## IMPORTANT SAFETY RECALL

NHTSA Safety Recall  
No. 20V-301

# Customer Service Notice

## Class III Receiver Hitch Inspection and Placard Installation

**Figure 1 — Inspection Area**

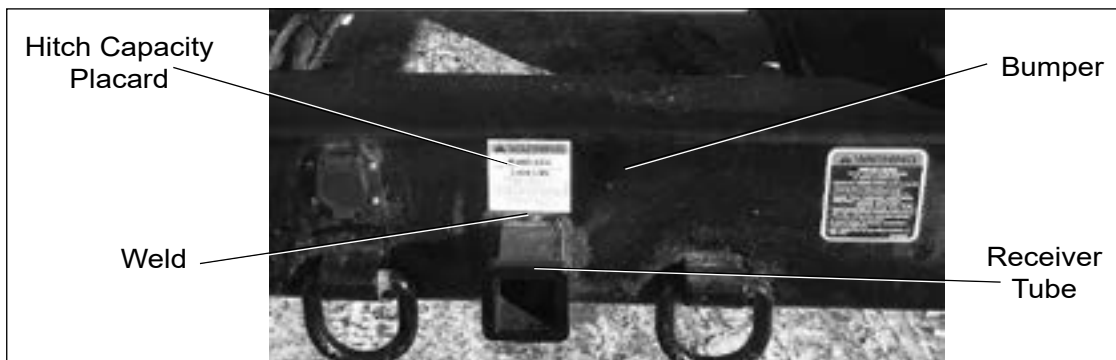
1. Position the unit on a level surface. Apply the parking brake and chock the wheels. Turn off the engine and remove the key from the ignition.
2. Look at the rear of the vehicle where the receiver tube is welded to the bumper (refer to Figure 1). If there is any dirt or debris on the weld area around the tube, clean this area with soap and water or other suitable cleaning solution to ensure that any potential defects will be visible.

3. Inspect the weld region all around the base of the receiver tube for any cracks.
  - If no cracks are present, proceed to the Placard Installation Procedure.

**Figure 2 — Minor Crack Example**

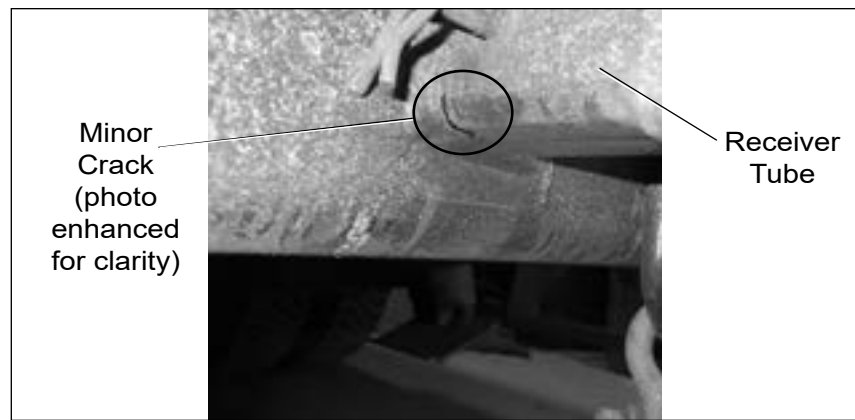
- If there are minor cracks, defined as cracks present only in the corner(s) or in the corner(s) and extending across no more than one full side, and the cracks have not opened up to produce a gap (refer to Figure 2), proceed to the Receiver Tube Repair Procedure.

- If there are major cracks, defined as cracks extending across two or more full sides or cracks that have opened up to produce a gap, or if there is structural failure (refer to Figure 3), proceed as determined below.
